U.S. Department of the Interior
BUREAU OF LAND MANAGEMENT

Well Name: NOW I WON 25-24 FEDERAL COM	Well Location: T22S / R31E / SEC 25 / SWSE / 32.3565542 / -103.7313051	County or Parish/State: EDDY / NM
Well Number: 2H	Type of Well: OIL WELL	Allottee or Tribe Name:
Lease Number: NMNM25365	Unit or CA Name:	Unit or CA Number:
US Well Number:	Operator: OXY USA INCORPORATED

Notice of Intent

Type of Action: APD Change

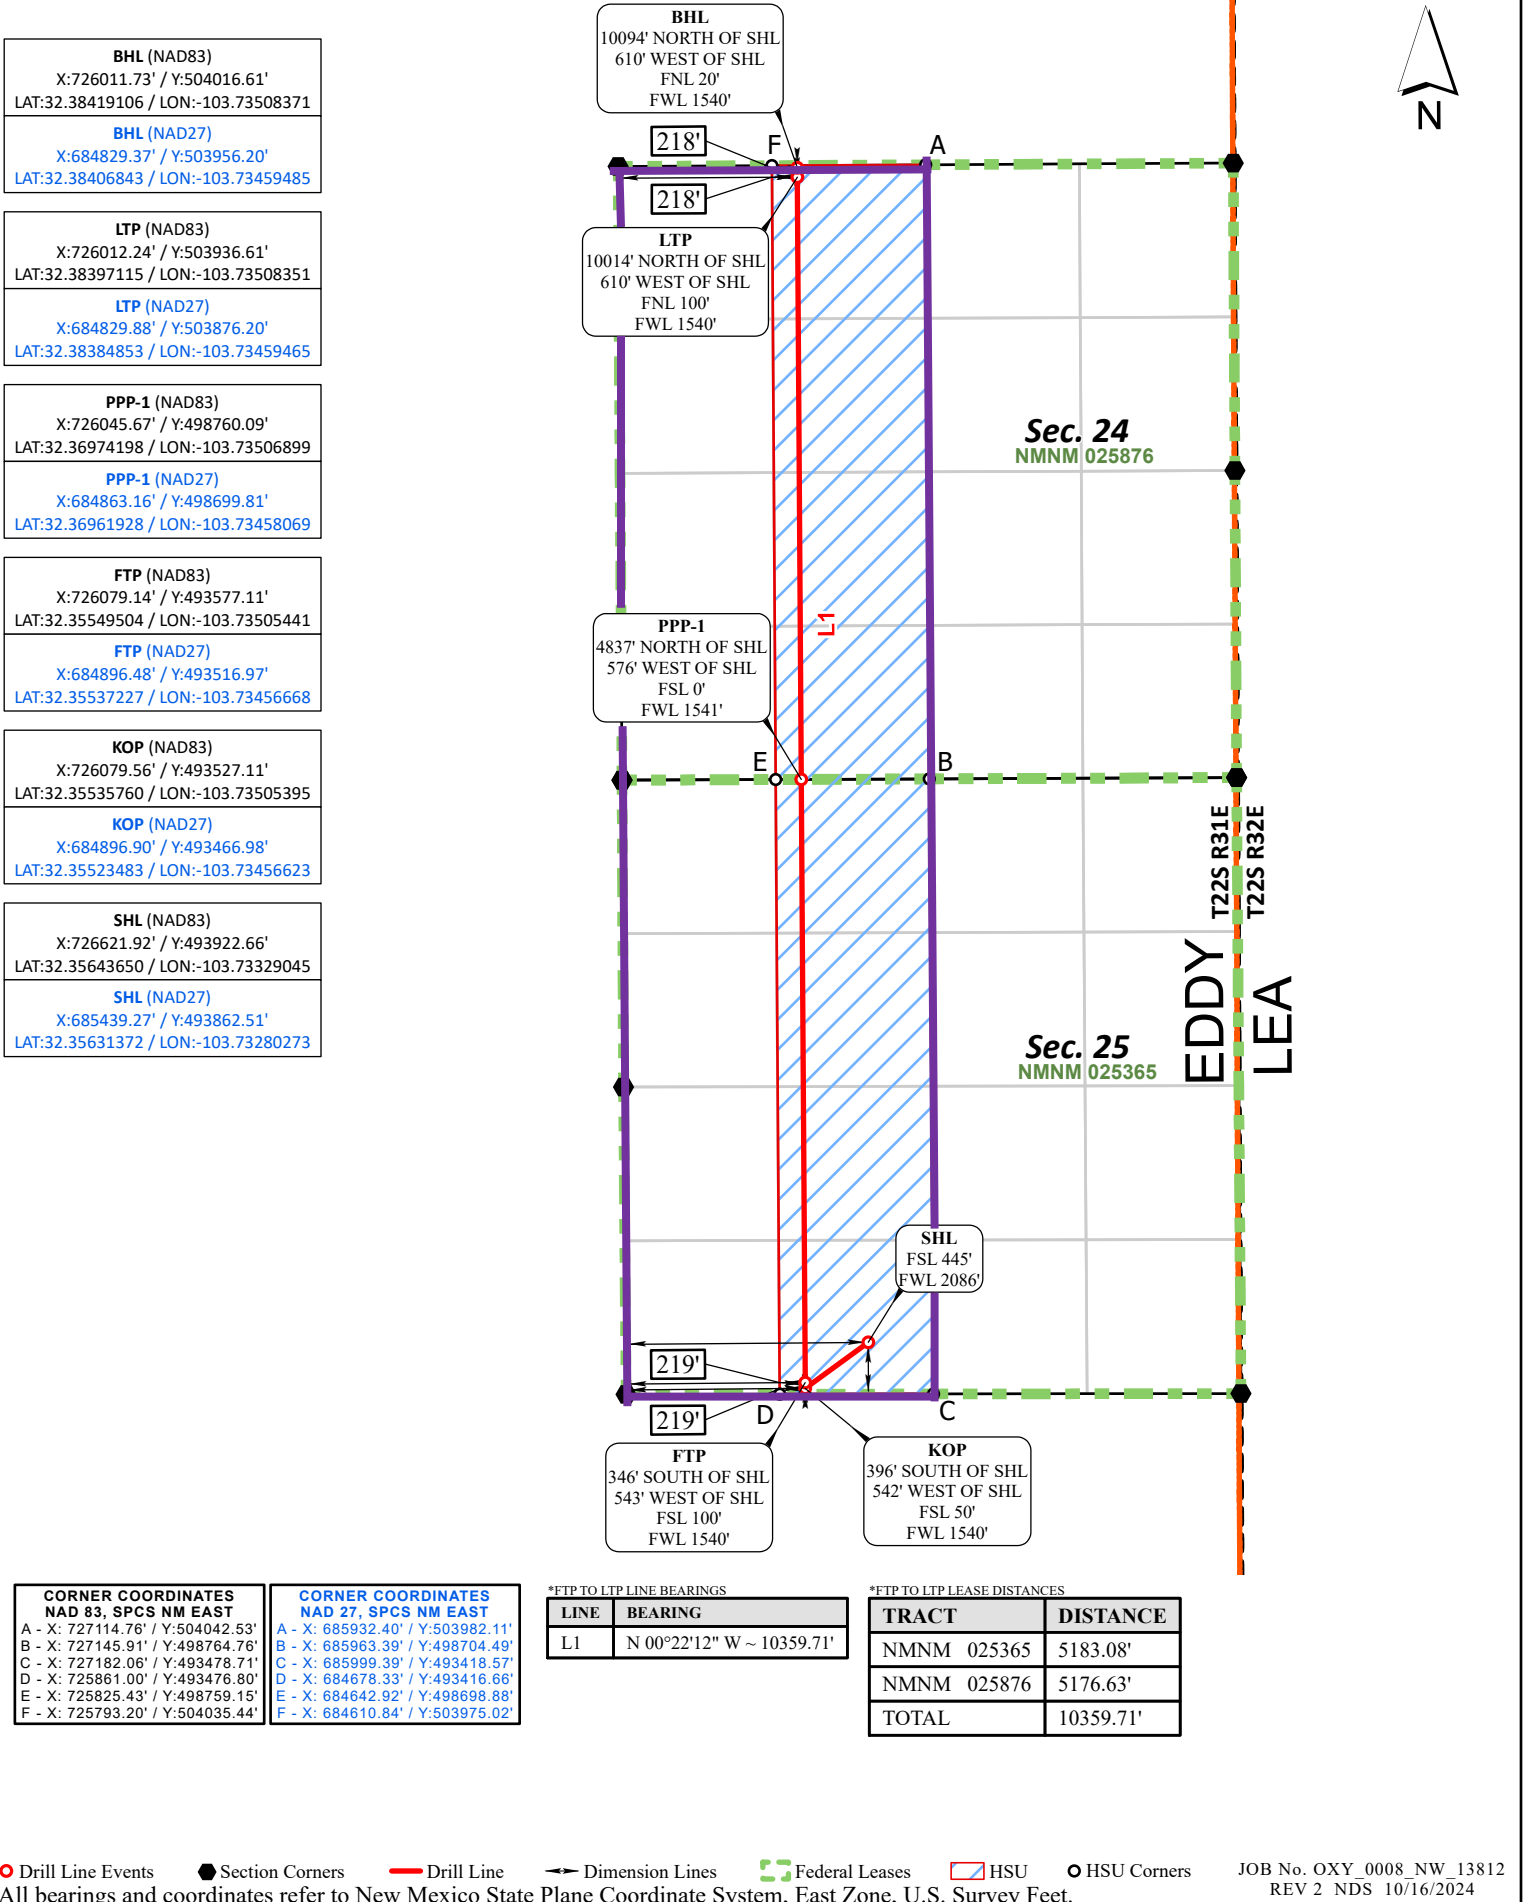
Old Well Name: NOW I WON 25_24 FED COM 2H
New Well Name: OLIVE WON UNIT 102H

Old SHL: 490' FSL 2586' FEL
New SHL: 445' FSL 2086' FWL

Old BHL: 20' FNL 2200' FWL
New BHL: 20' FNL 1540' FWL

Old HSU: 320 acres
Continued on page 3 additional information

New HSU: 640 acres

Attached is the updated C102, drill plan, blanket design A, directional survey, casing specs and APD Change Worksheet.
